# **DATA REQUEST RESPONSES**

**SOLAR ENERGY GENERATING SYSTEMS (SEGS) VIII AND IX  
(88-AFC-01C AND 89-AFC-01C)  
BATTERY ENERGY STORAGE SYSTEM**

September 2019

TERRA-GEN	JOB NUMBER	REV
	SEGS VIII BESS & SEGS IX BESS		1
	Figure 1: One Line Diagram	DRAWING NUMBER	SEGB-1

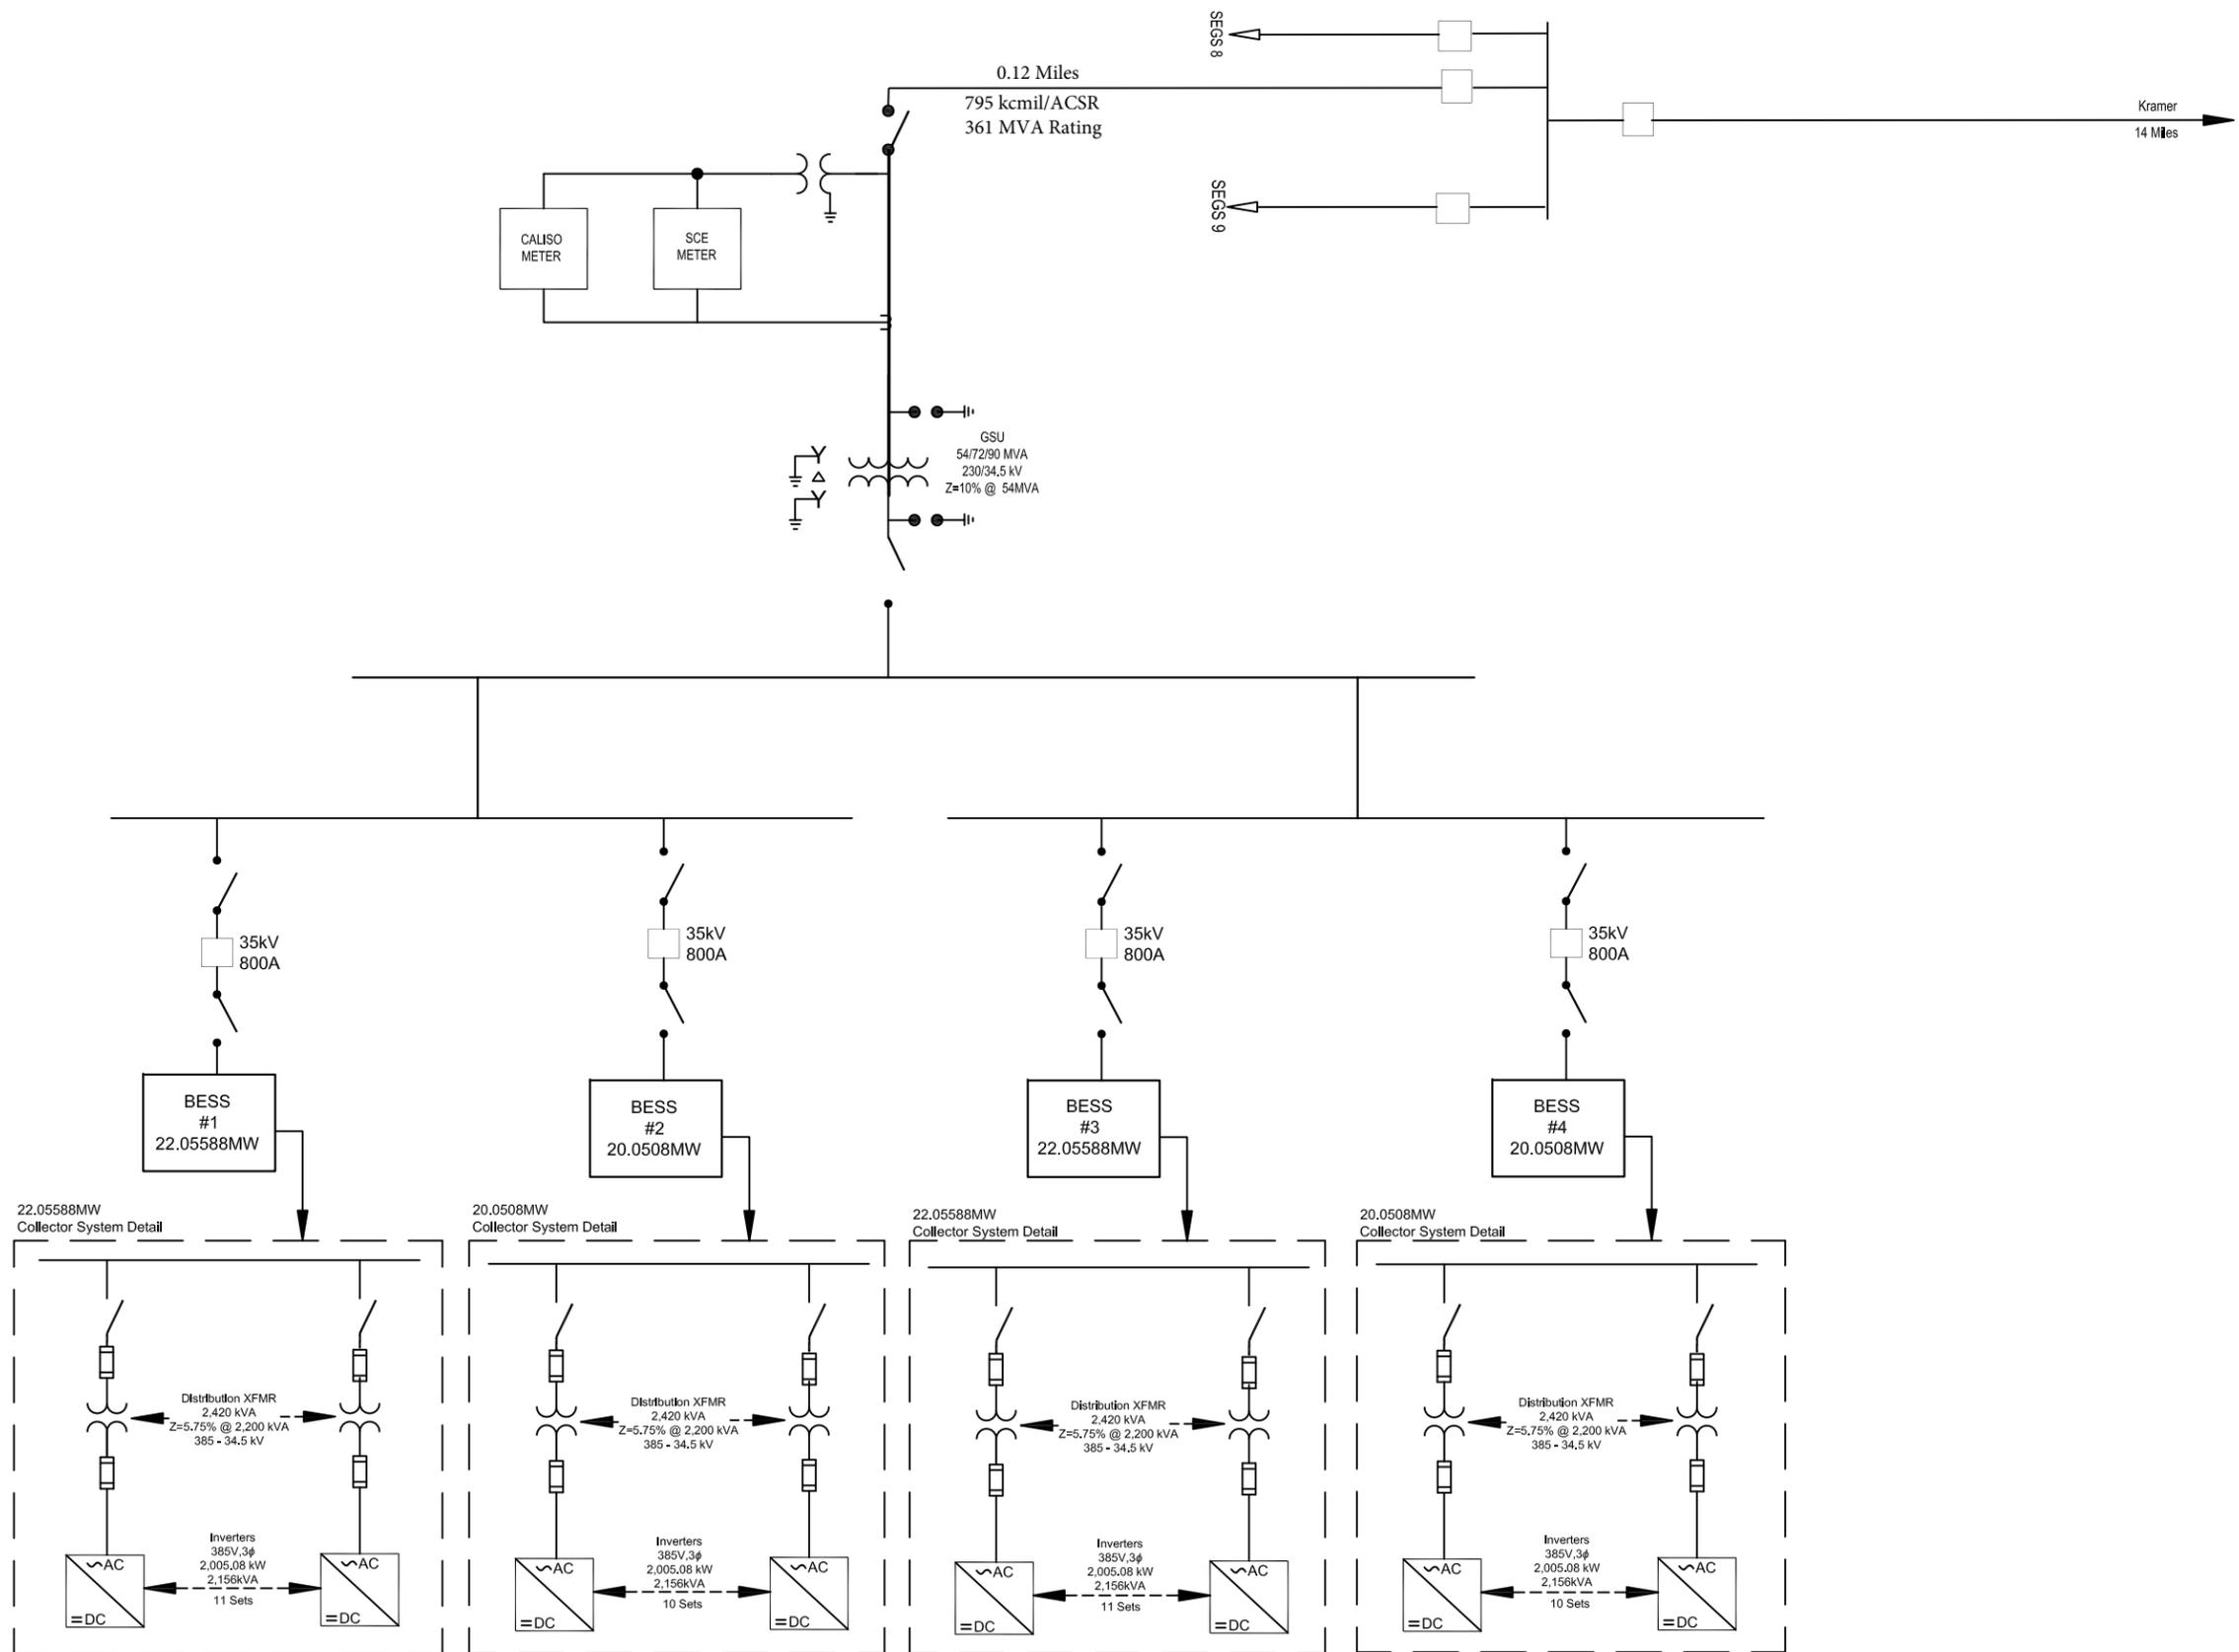
**Data Request A2:** *Please provide one-line diagrams of the BESS with detailed information on how it would be interconnected with the existing SEGS VII and SEGS IX plant substations.*

**Data Request A3:** *Please provide detailed schematic diagrams of the SEGS VIII and SEGS IX and their interconnections to the proposed BESS and to the California ISO - controlled grid. Please indicate the feeder ratings such as DC voltages, conductor type and size and current carrying capacity, and fuse/breaker coordination information.*

See attached Figure 1, One-Line Diagram.

See attached Figure 2 and 3 that show an aerial view of the existing plant high voltage electrical transmission systems and the proposed location of the modification to the on-site switchyard to accommodate the BESS. The BESS system will connect to the existing plant switchyard by adding a new breaker and switches connecting to a common bus with the existing SEGS VIII and IX units. Please refer to the Figure 1, One-Line Diagram, for voltages, ratings, and configuration of the combined BESS and SEGS VIII and IX units.
